**Addendum No. 2  
January 19, 2024**

Project: **Lennox High School Addition**  
Lennox, South Dakota  
Architecture Incorporated Project No.: 2982

Architect: Architecture Incorporated

LENNOX HIGH SCHOOL ADDITION  
FIRST FLOOR PLAN - AREA E - PLUMBING & HEATING

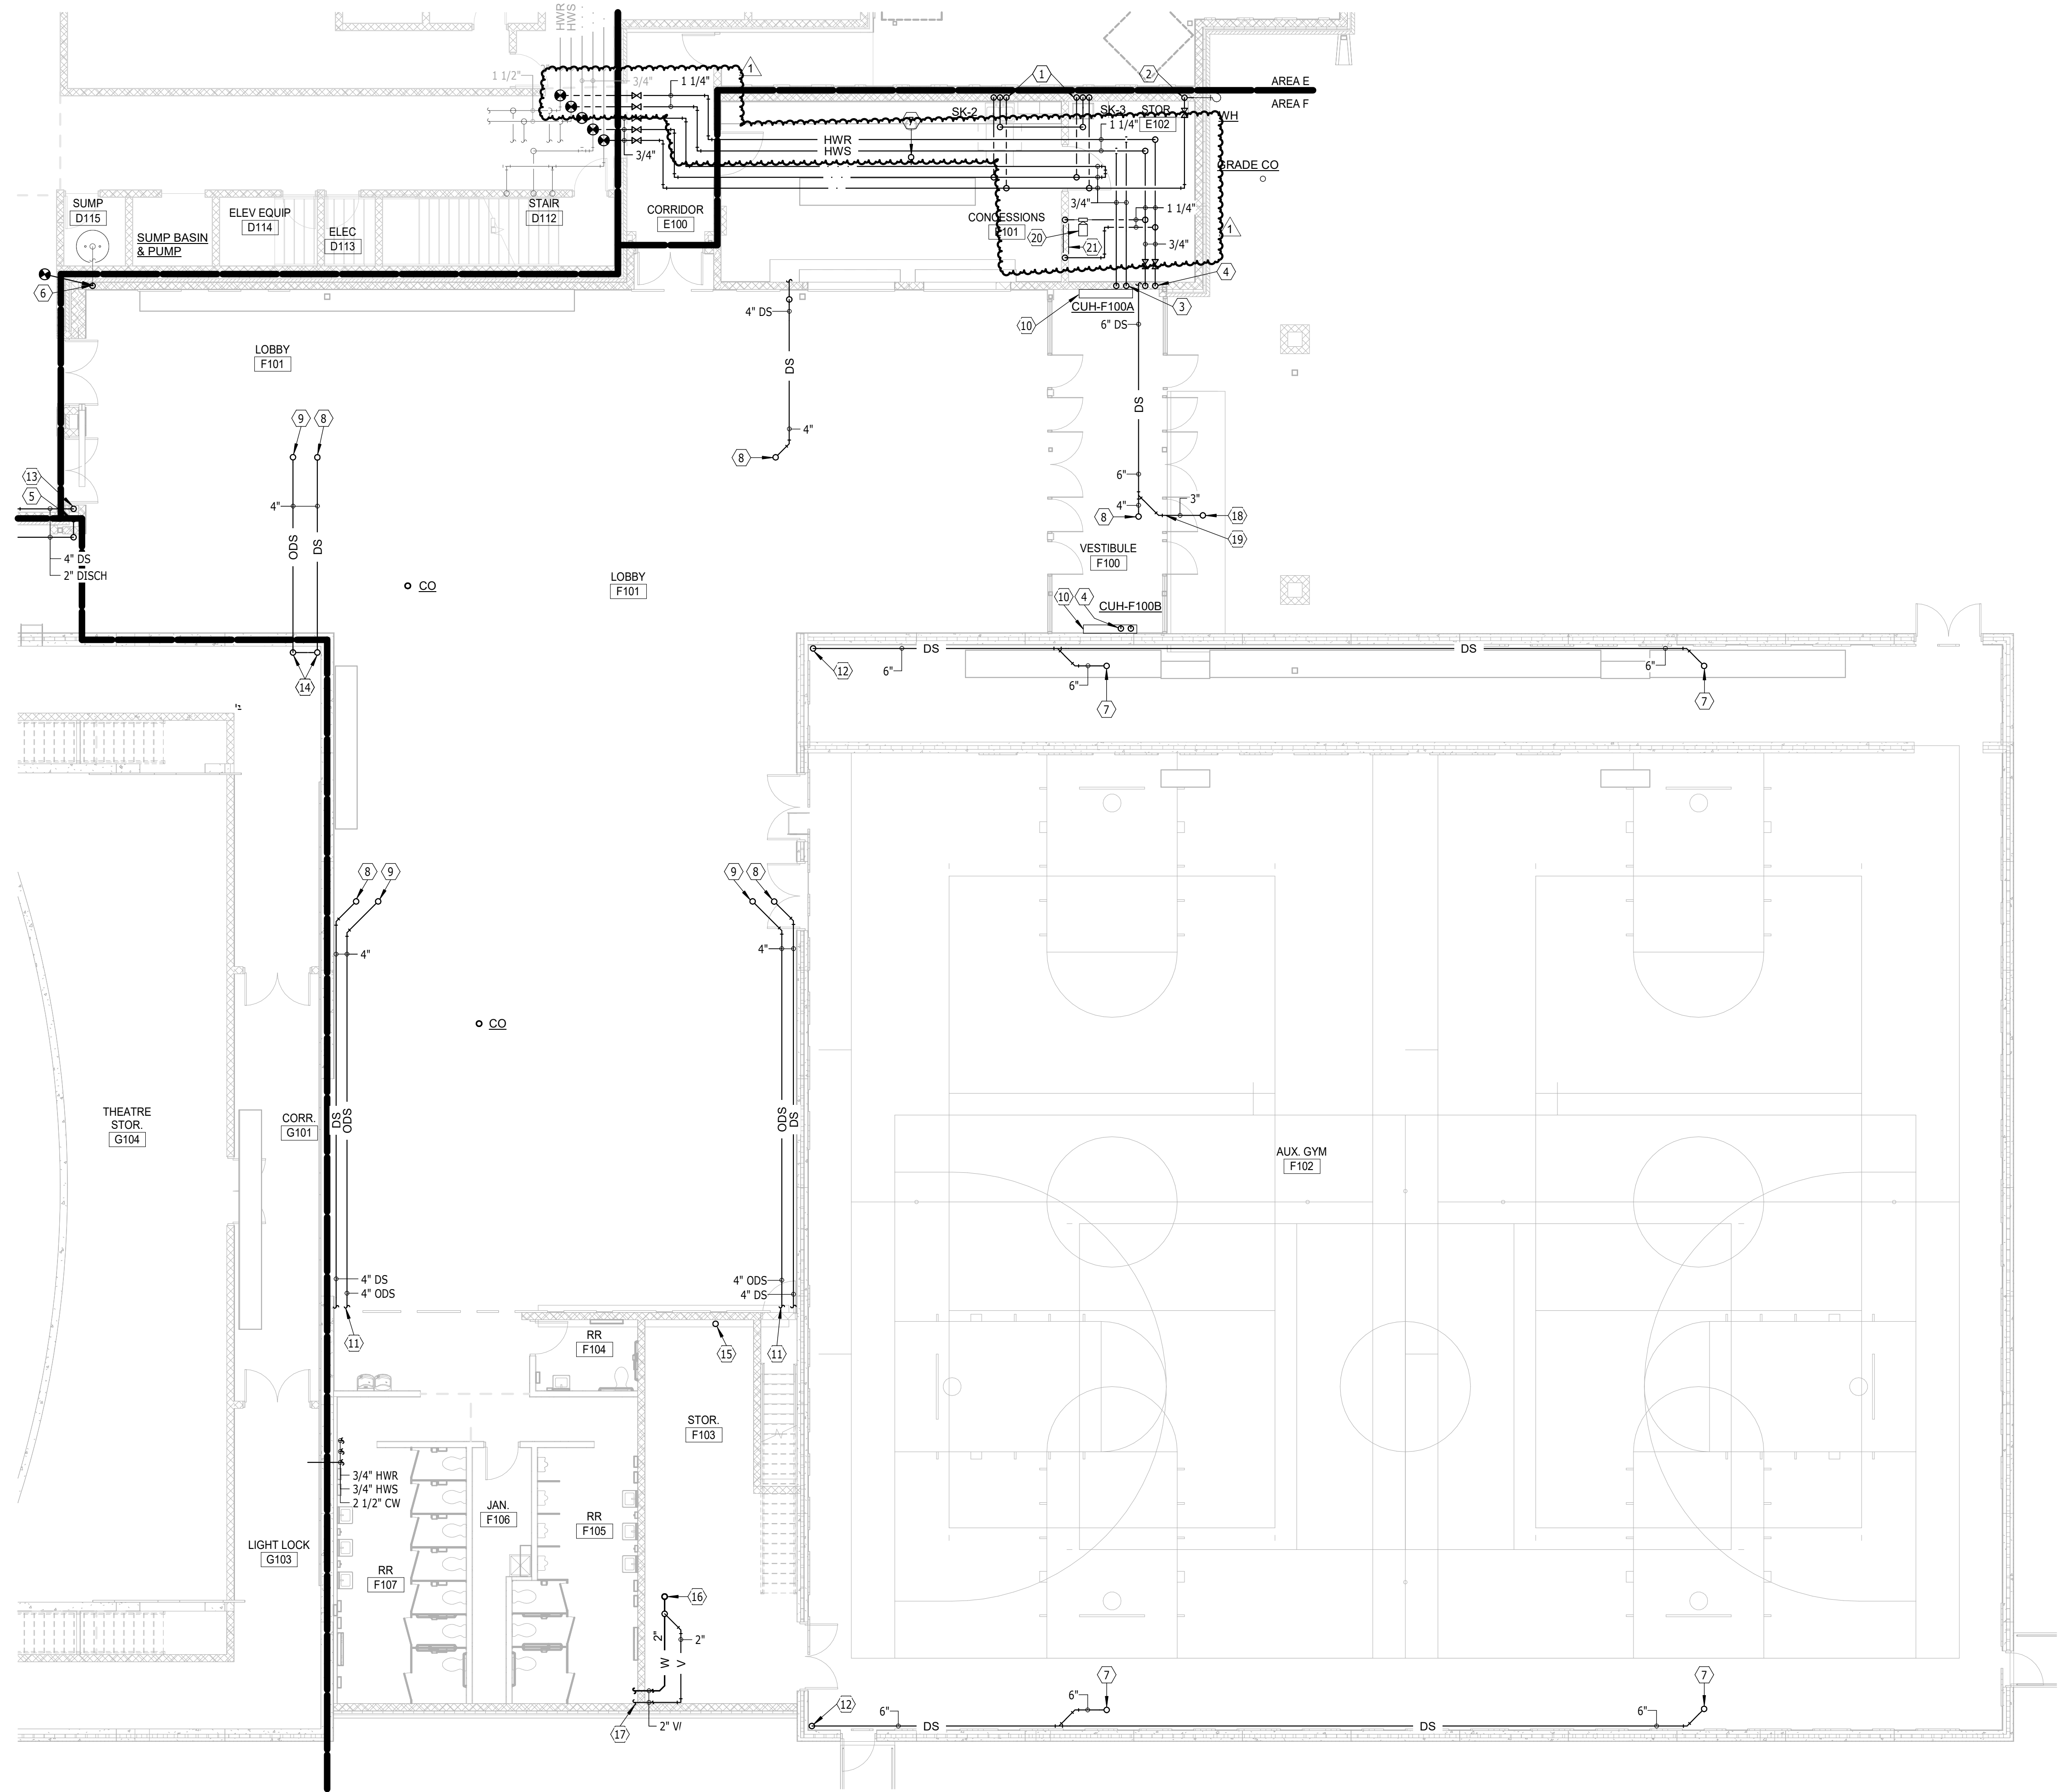
5) SHEET 8.31 -E – FIRST FLOOR PLAN – AREA E – PLUMBING & HJEATING

- a) Add infloor heat zone & accessories as indicated per *revised* mechanical drawing Sheet 8.31-E, dated 1-18-24, attached to the end of this addendum.

# 8.31-F-A

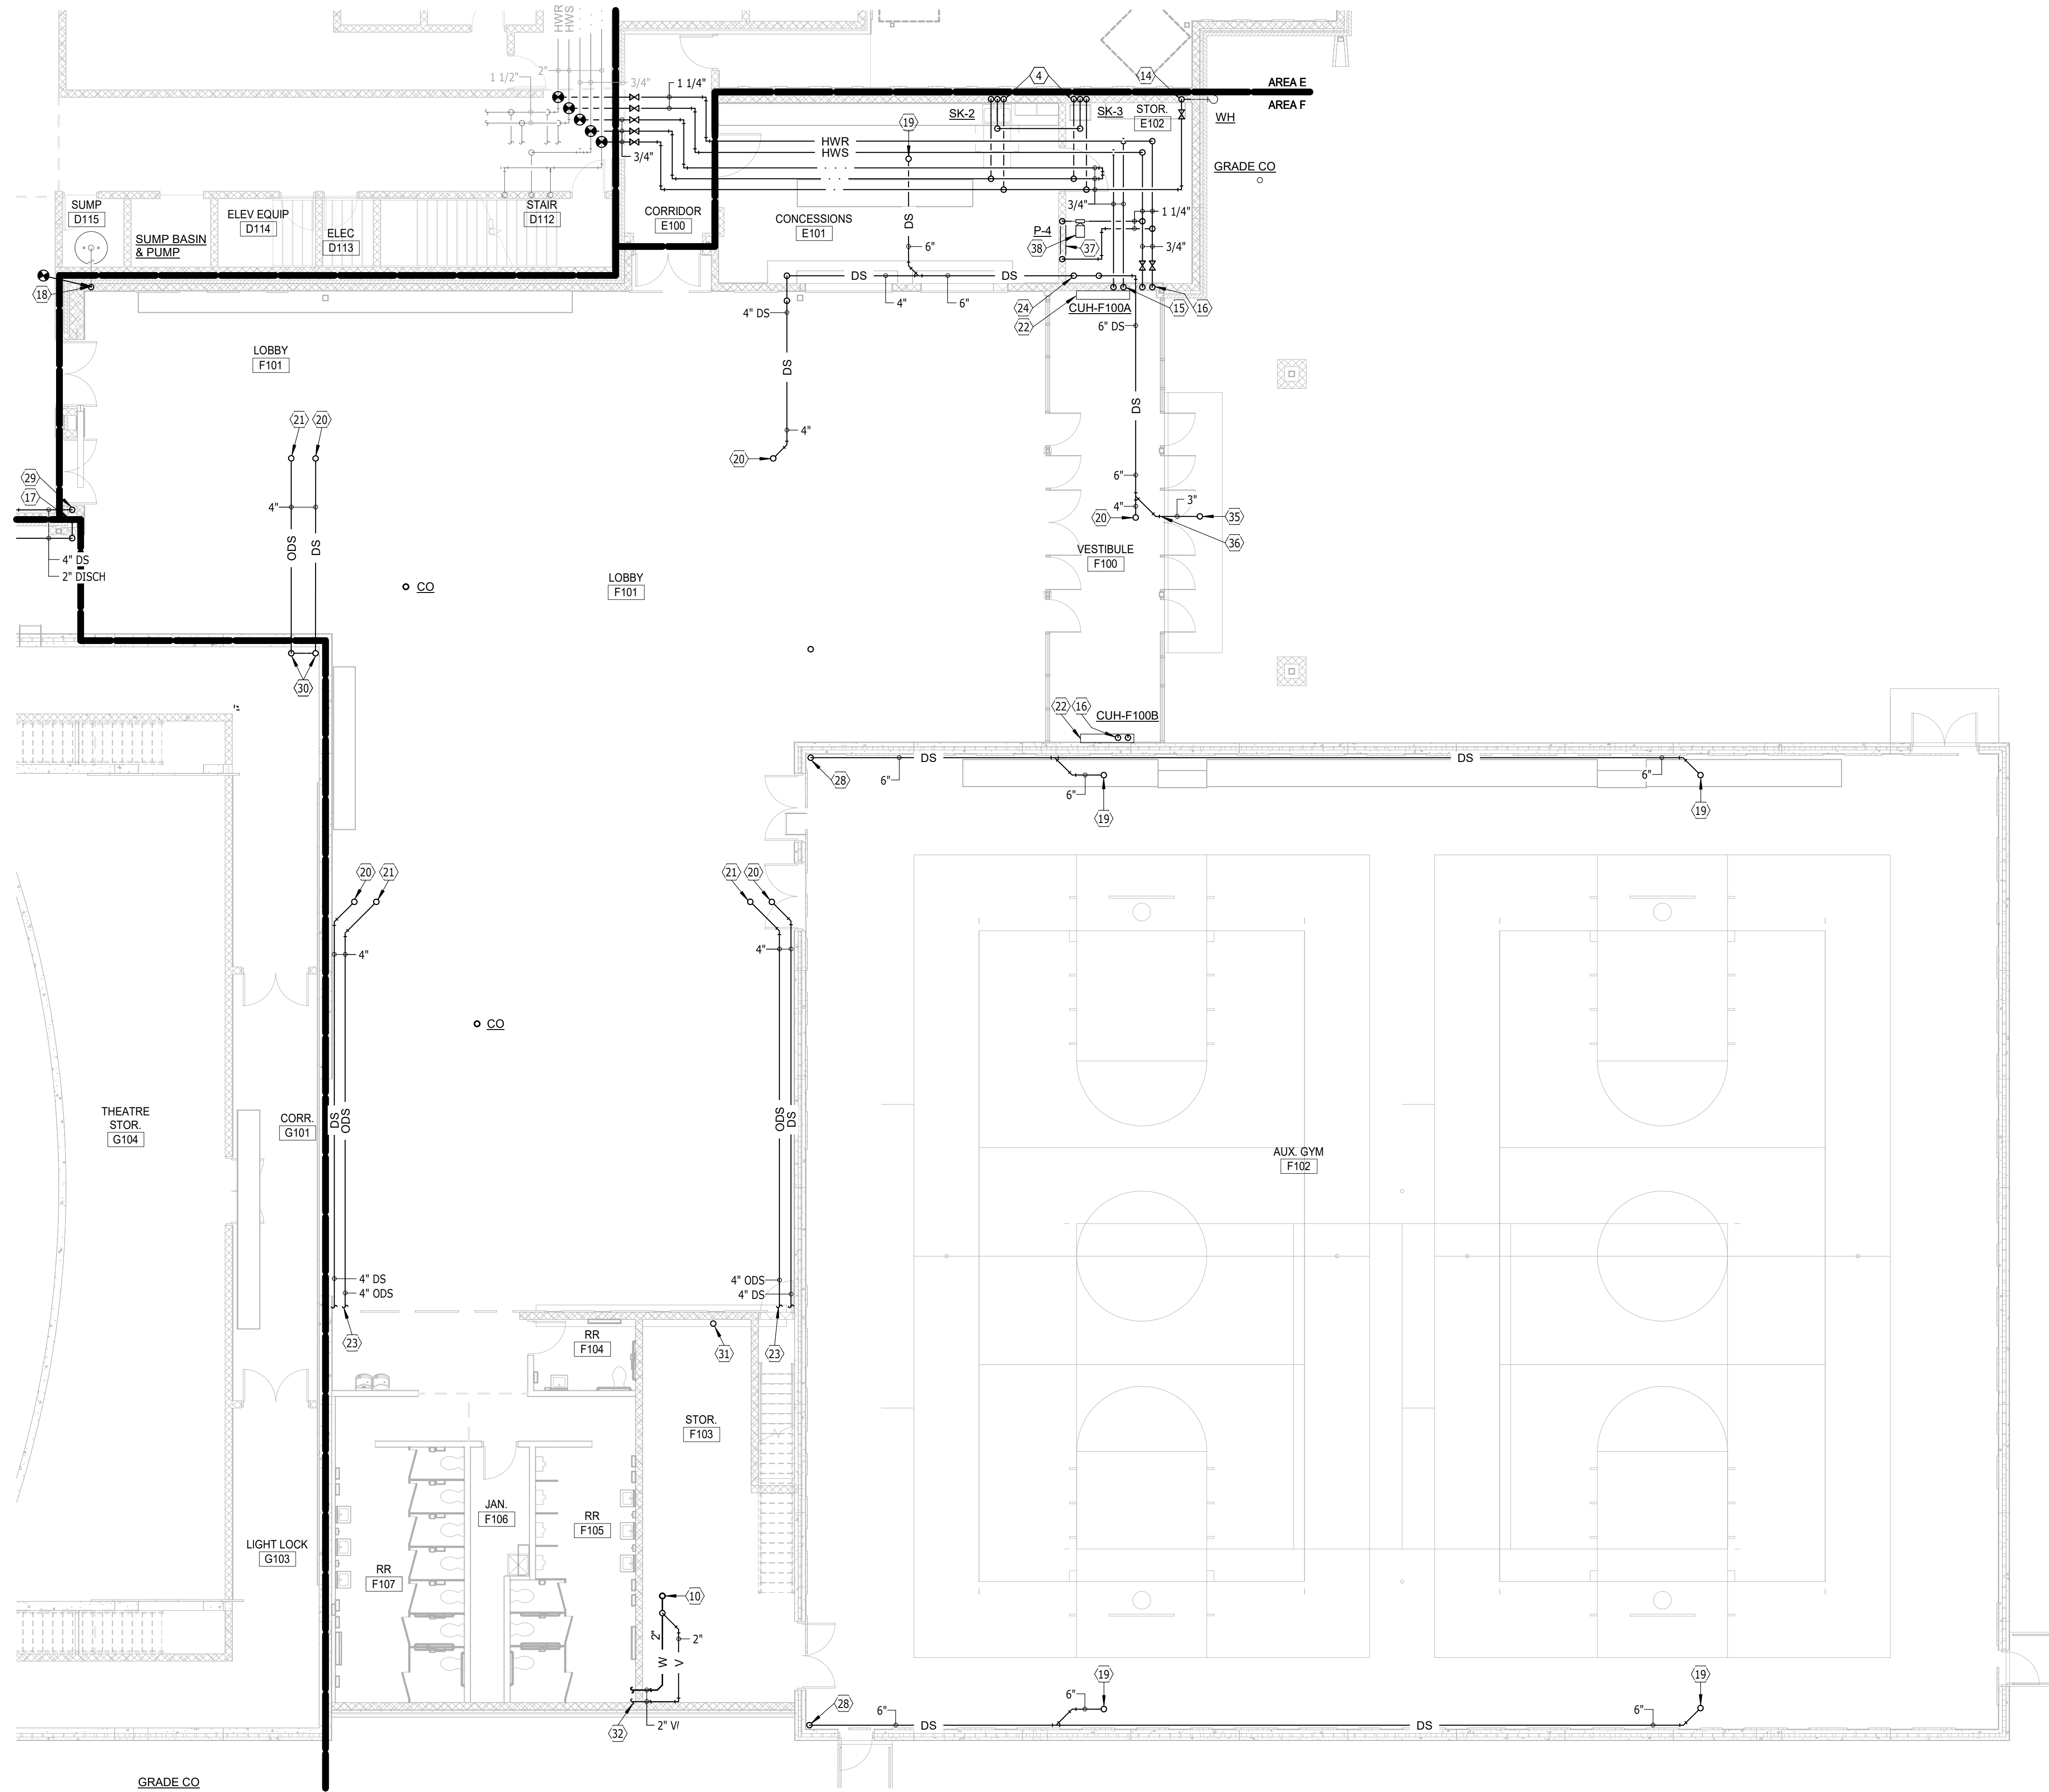
7) SHEET 8.31-F-A - 1<sup>st</sup> FLOOR PLAN - AREA F - PLUMBING & HEATING - ADD ALTERNATE

- a) Add infloor heat zone & accessories as indicated per *revised* mechanical drawing Sheet 8.31-F-A, dated 1-18-24, attached to the end of this addendum.
